SUNDRY NOTICES AND REPORTS ON WELLS

Energen Resources Corporation

Carracas Unit 10A # 16

30-039-30468

Carracas 10 A #16 ST01 R3 ors 04-Sep-08
Carracas 10 A #16 MWD DMAG 0' to 4252' Depth shifted Survey

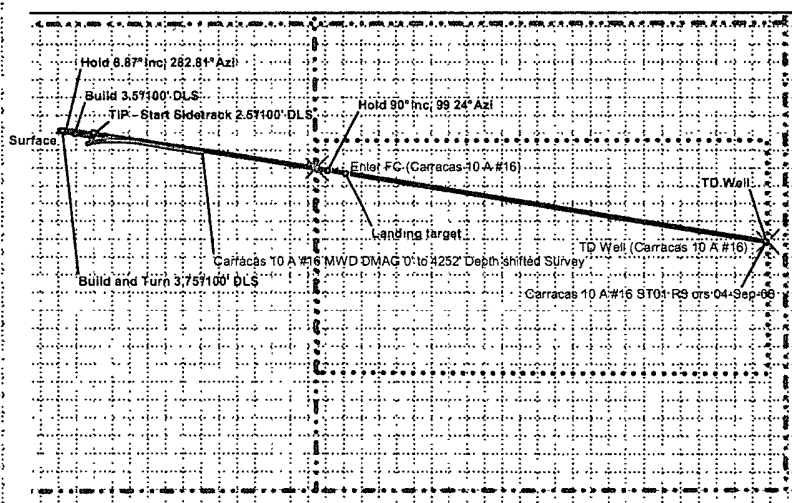
Due to an inaccurate pipe tally from rig personnel an excess of 126' was drilled past the original KOP of 2700' on the Carracas 10A #16. Energen Resources would like to spot a 500' cement plug from 1080' to 1580' MD. KOP will change from 2700' to 1280'.

Intermediate Casing will increase to a measured depth of 5050'. Cement volume will remain unchanged.

Attached is schematic of the plugging parenters and a revised directional plan.

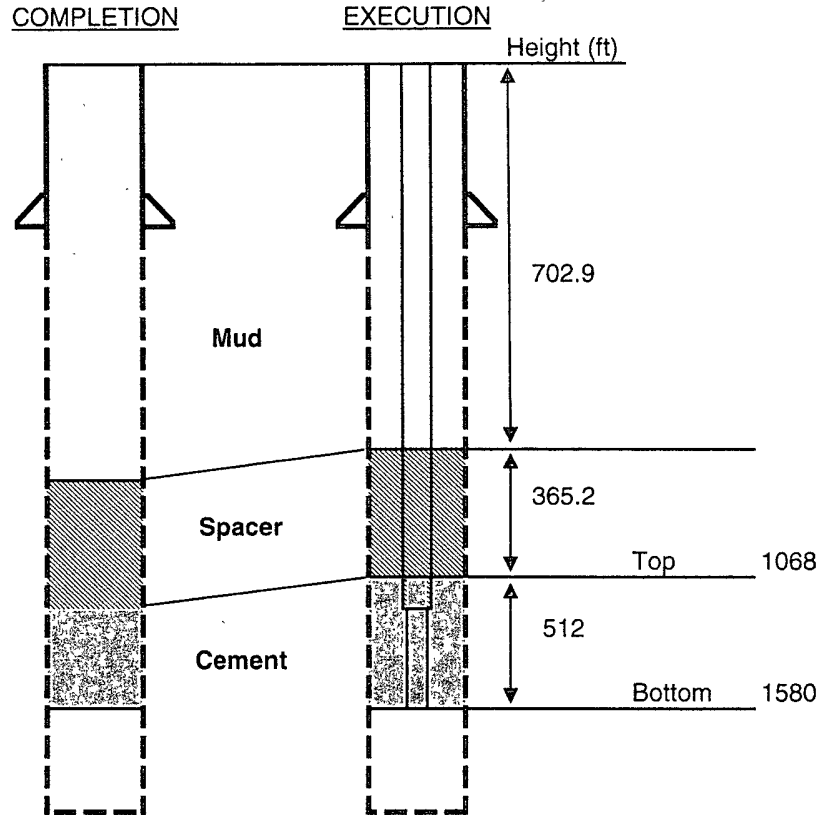
Cement Plug: Consists of 205sx of Class "G" cement mixed @ 16.5 ppg and yield of 1.03 cuft/sk. Total volume will consist of 209 cu. ft.

* Verbal Consent from BLM Representative: Jim Lovato - to set plug from 3050' - 2550'.
- No record of authorization given to change plug to 1080' - 1580'. See BLM approved dtd. 9/5/08
